HotWire 7925 E1 HDSL Standalone Termination Unit Errata

Document Number 7925-A2-GK40-00

August 1997

Figure C-2. V.35-Compatible Unit Switchpack and Jumper Locations

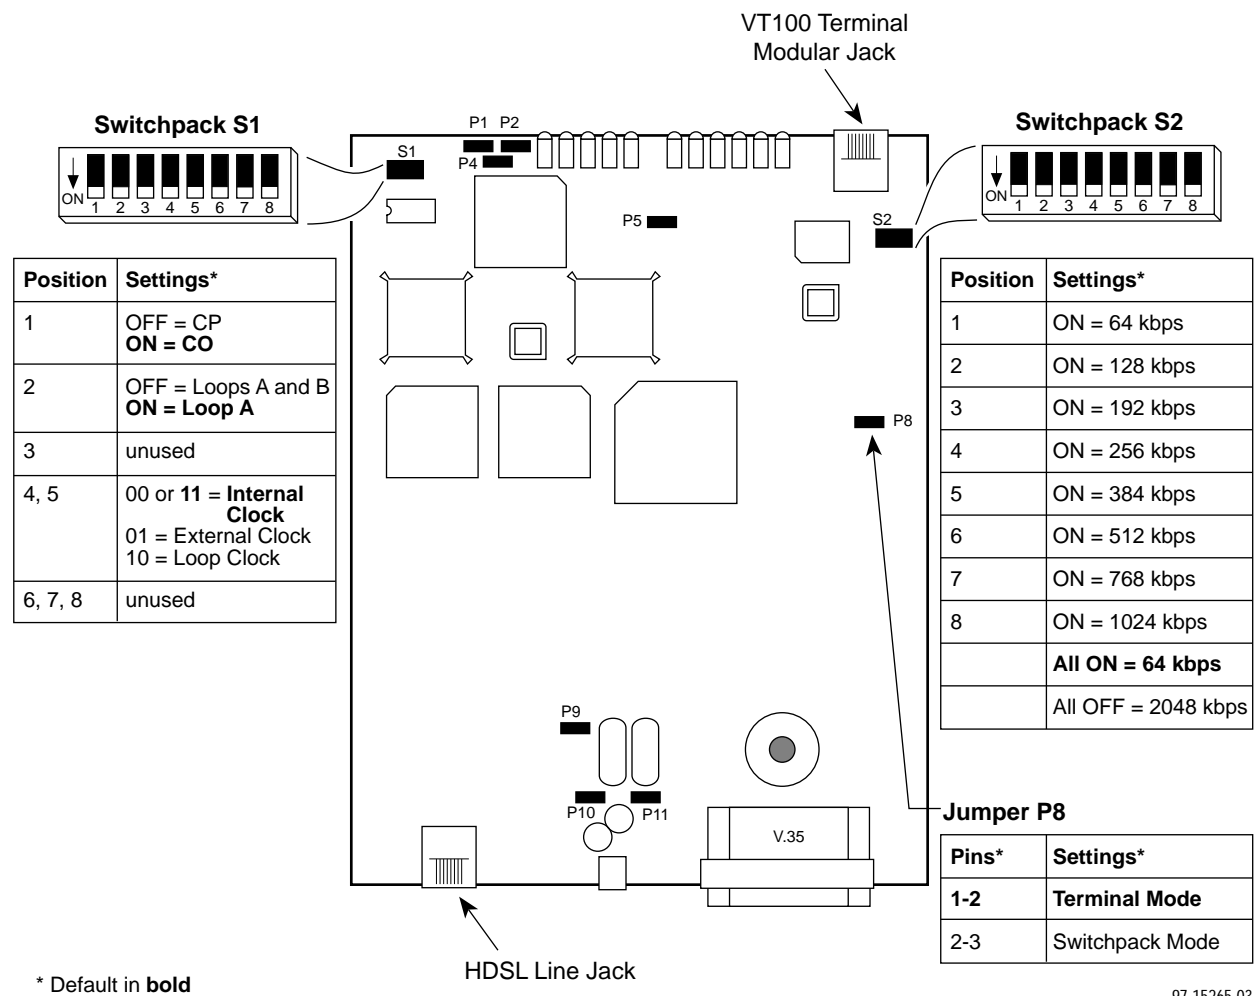
Page C-4 shows the switchpack definitions for V.35-compatible units. In the table on the left for Switchpack S1, the definition for Switch Position 1 is incorrect. The correct definition is:

Switch Position 1: OFF = CP
 ON = CO (default setting)
